SAMANALAWEWA HYDROELECTRIC PROJECT

THIRD PARTY REVIEW PANEL

REPORT SMW-1

REPORT SMW-1

FIGURE 6

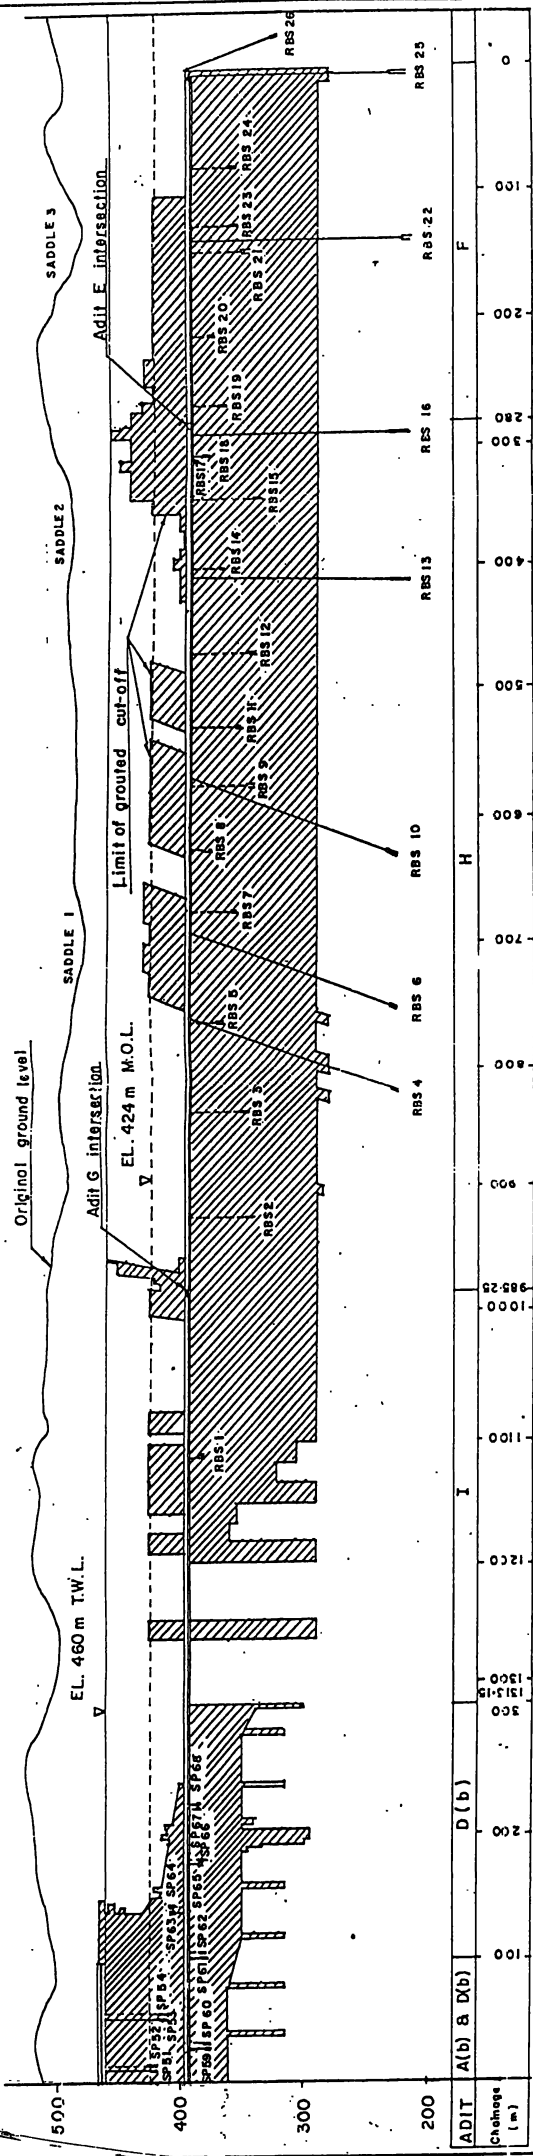
Only very few spots have been grouted above the adit up to El. 424 and rarely to El. 460 (see figure 6), taking into account the geological data collected in the adit (areas with open fractures, fault and shear zones) but it is not sure that ungrouted windows have not been left. Certain sections between CH 1200 and CH 1315 have not been grouted, being considered impervious. Check holes or observation wells equipped with a slotted plastic pipe should be drilled to control this extrapolation. Grouting has reduced the void ratio of the curtain by up to 95 %.

REPORT SMW.1
 30 December 92 | Figure 6 bis

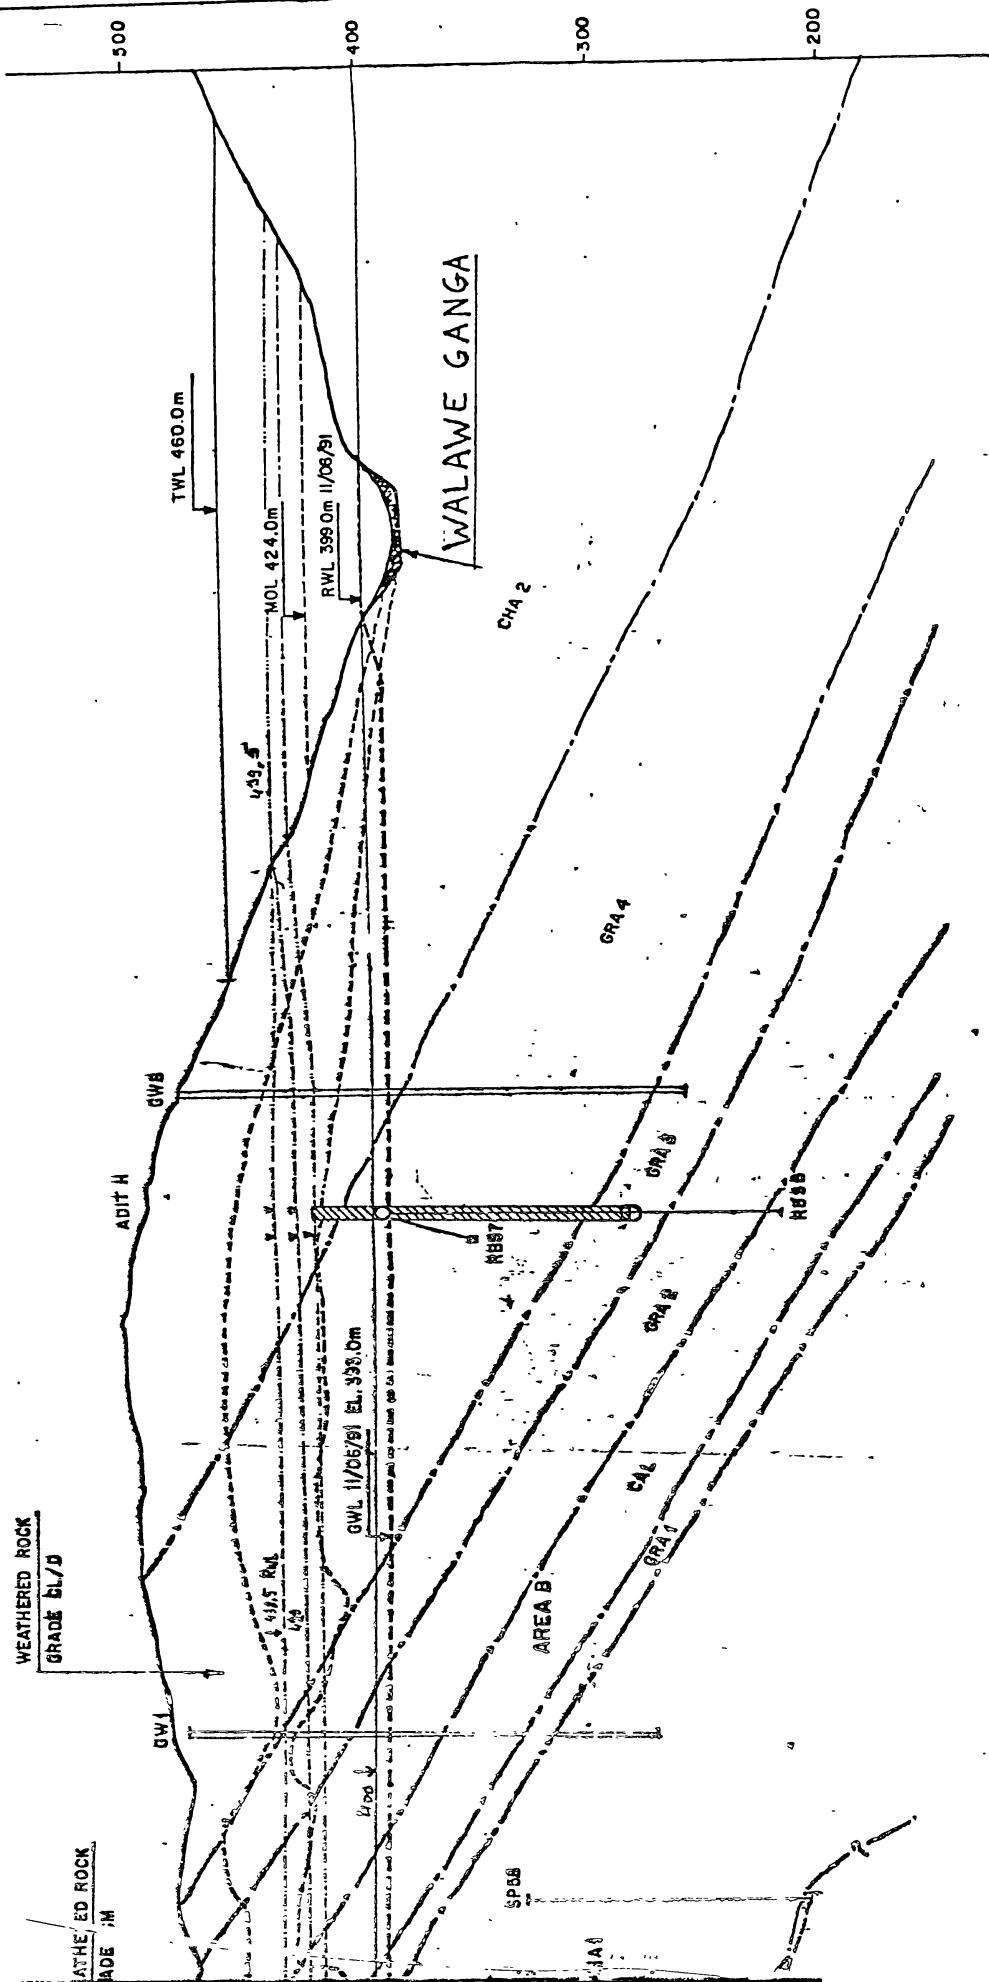
Special attention should be paid to the evolution of piezometers in the immediate vicinity of the Dam Right abutment which can be by-passed by the leakage route I bis (see figure 6 bis) using shear joints and tensional fracture joining Fault system F₁. It should be noted that certain of the piezometers (see document C annex fig. J-10 and J-11) placed upstream and downstream of the grout curtain Db have been affected

HEAD OF A DRAINAGE
HOLE THROUGH
THE ROCK

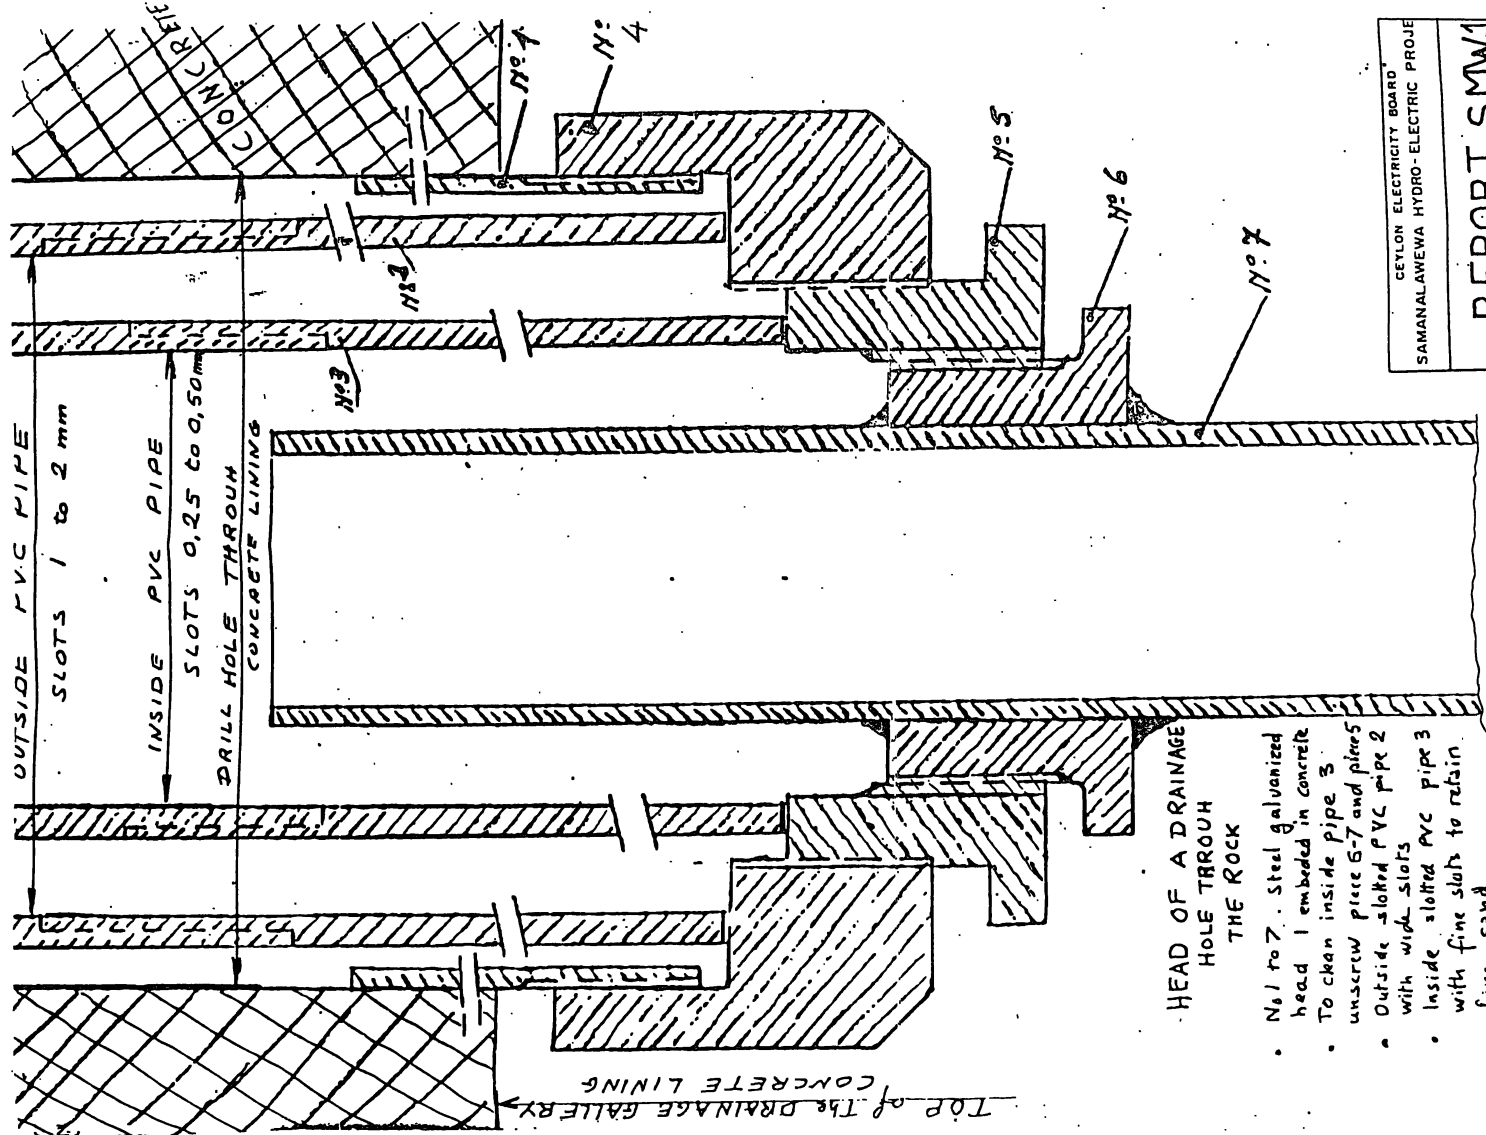
With the drainage curtain AD from a gallery at Elevation 400-415 (see figure 9), the dam and its vicinity are fully protected against an unforeseen high water table.

Two alternatives have been considered (see figure 9):

- the first one AD is located just around the dam abutment with its invert starting from El. 415 approx. at point D to reach El. 400 at the portal A. At the same time the dead end (on about 100 m long) of the abandoned grouting gallery D could be used as a drainage adit. The same applies to the access adit Da to protect the immediate proximity of the dam,
- the second one BD extends from the end of adit D at a higher Elevation (about 415) to the access adit E at El. 400 approx. This alternative is longer than the first one and it does not seem necessary to protect saddles 2 and 3, if the seepages are substantially reduced by the remedial measures, because the seepages in the Kulaneida ara are far enough from the dam toe.
